TECHNICAL BULLETIN	
	February 1998 TB 1546
Mfg:	TOYOTA
Model:	4-RUNNER
Liter:	3.0L
V I N:	3V-ZE
Year:	88-95

Cylinder Head Installation On
1987-94 Toyota 3.0L 3VZE Engines

Bulletin Diagram: Untitled Graphic #2296 for TB 01546

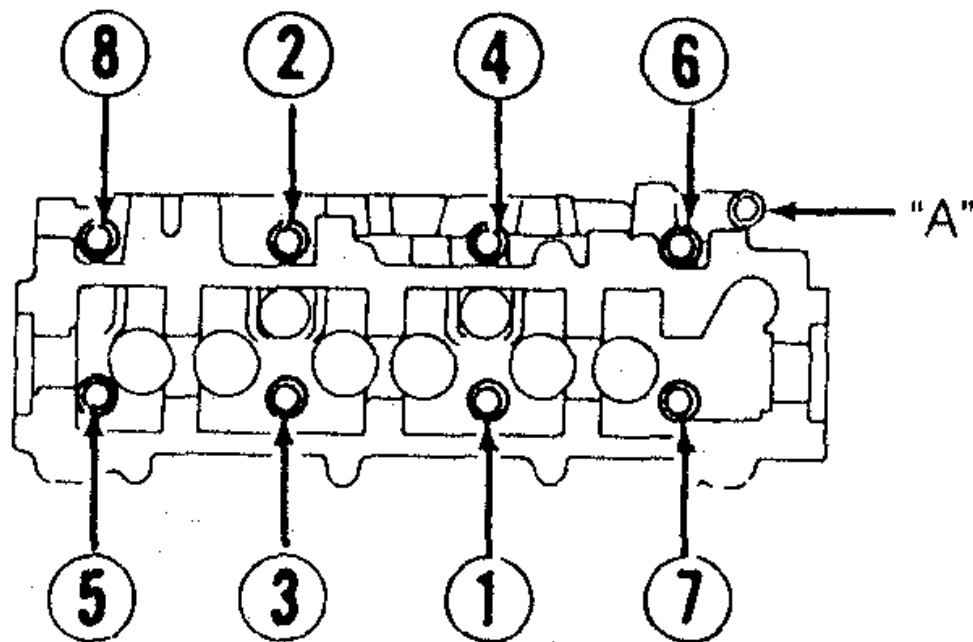
The AERA Technical Committee offers the following information regarding cylinder head installation on 1987-94 Toyota 3.0L 3VZE engines. Apparently, some service manual information is inaccurate in the torque values listed for mounting this engine's cylinder heads. A previous AERA publication, ES-40R also lists an incomplete value for cylinder head bolt torque.

This engine uses a torque-turn method of tightening the cylinder head mounting bolts. The final bolt movement involves rotating the bolt 90° tighter than the previous turn. This engine requires two additional 90° rotations from the initial torque of 33 ft/lbs. Some previously published information has omitted the second 90° turn. The manufacturer of this engine does not dictate cylinder head bolt replacement unless they are damaged. Follow the procedures and torque sequence illustration listed below for cylinder head installation.

If an engine is assembled and placed into service with a deduced amount of applied torque to the cylinder head bolts, premature head gasket failure will result.

1. Install each head gasket on block deck at their intended cylinder bank (See AERA Technical Bulletin TB 1197).
2. Apply engine oil to bolt threads and head underside and install.
3. In sequence tighten all bolts except bolt "A" to 33 ft/lbs.
4. In sequence tighten all bolts except bolt "A" an additional 90°.
5. In sequence tighten all bolts except bolt "A" an additional 90°.
6. Install bolt "A" and tighten to 27 ft/lbs.
